SERVICE BULLETIN

PRODUCT: Computer Monitor
BULLETIN: Monitor 95-004
MODEL: CMB5477L

SUBJECT: CRT Substitution

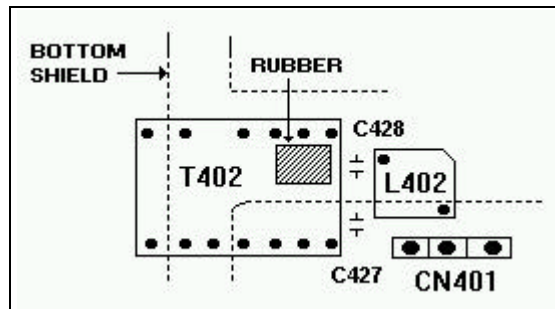
SUBJECT: To prevent whistling sound from occurring.

BACKGROUND: A whistling sound is created from harmonic noise generated between T402, L402, and the main PCB near the Flyback Transformer.

SOLUTION: Add a piece of rubber to insulate the main PCB solder side from the bottom metal shield. See Illustration below showing the section of the PCB where the rubber will be located.

Part No.	Description
BH61-30303A	RUBBER

Figure 1

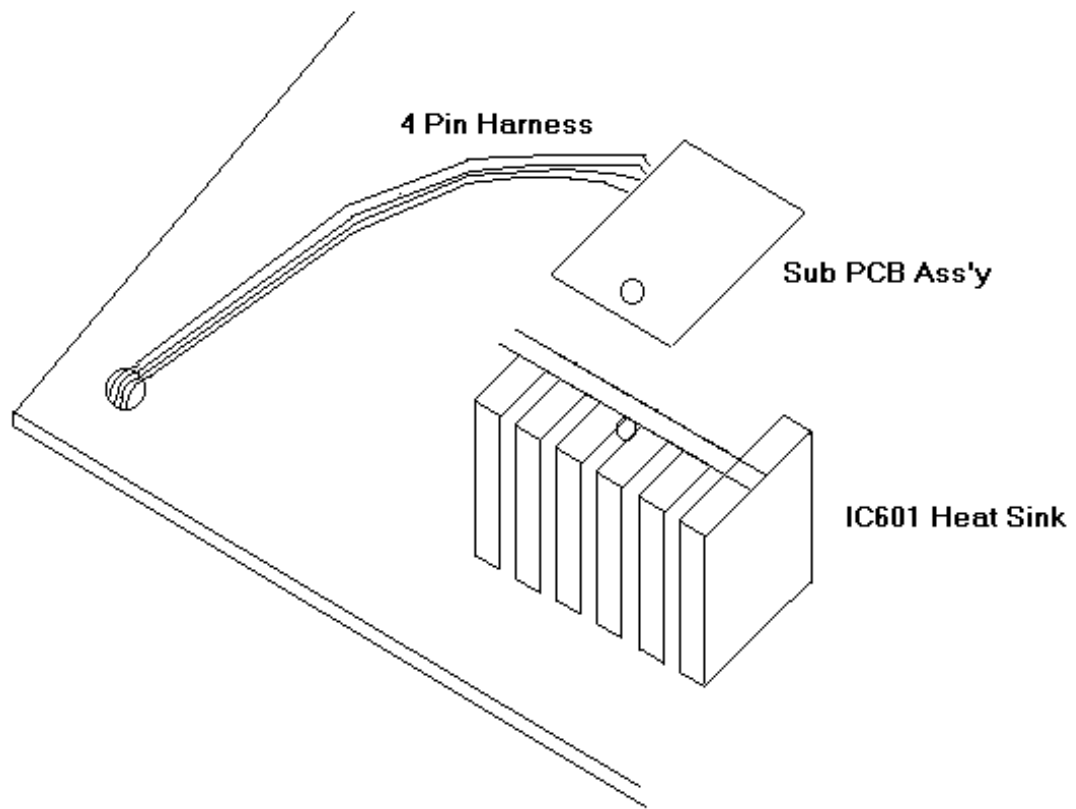
SUBJECT: Q407 Failure Causing No Raster or Small Horizontal Size

BACKGROUND: Q407 fails due to a transient pulse and current when mode switching from DOS to Windows. This occurs with a Matrox video card installed in the computer.

SOLUTION: Add a sub-PCB assembly as in figures 1 and 2 and a snubbing circuit for the horizontal output as in figure 3.

ORIGINAL			NEW	
Location No.	Part No.	Description	Part No.	Description
NA	NA	NA	BH92-50106J	SUB-PCB ASSEMBLY
NA	NA	NA	BH39-40355S	4 PIN CBF-HARNESS
NA	NA	NA	6003-000129	TAPTITE SCREW
NA	NA	NA	0401-000005	1N4148 DIODE
NA	NA	NA	0402-000012	UF4007 DIODE
NA	NA	NA	2003-000009	220 OMHS, 1 WATT
